February 21, 2019

MS-18-00535 South Hills No. 3 Second Replat, a Minor Subdivision/Replat of Lots A-1 and A-2, A lot split for lot A in the replat of South Hills No. 3 together with Lot B, a replat of South Hills No. 3, both being subdivisions in the City of Lawrence, Douglas County, Kansas. Submitted by Opus Development Company LLC on behalf of George B. and Marlene J. Leinmiller, the property owners of record.

ADMINISTRATIVE DETERMINATION: The Planning Director approves the minor subdivision.

Figure 5: Proposed dedication of right-of-way and utility easement

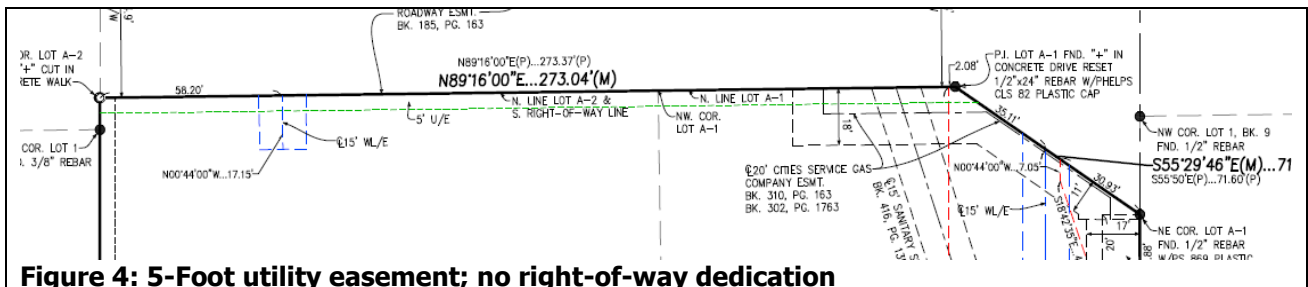
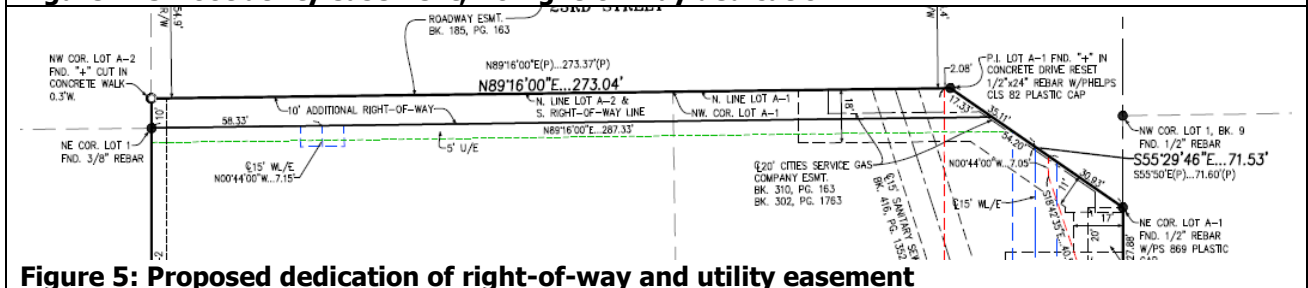
The Planning Commission discussed this project at their January meeting and directed the applicant to reserve area for pedestrian access along W. 23rd Street. The applicant revised the drawing to show the dedication of 10 feet of additional right-of-way along the north property line. The previous drawing showed a 5 foot utility easement along the north property line. This proposed right-of-way dedication will replace and expand the area to accommodate a pedestrian sidewalk and any utilities required in this area.

This change aligns the property line with the abutting properties to the east and west creating a uniform street width along this segment of the street corridor.
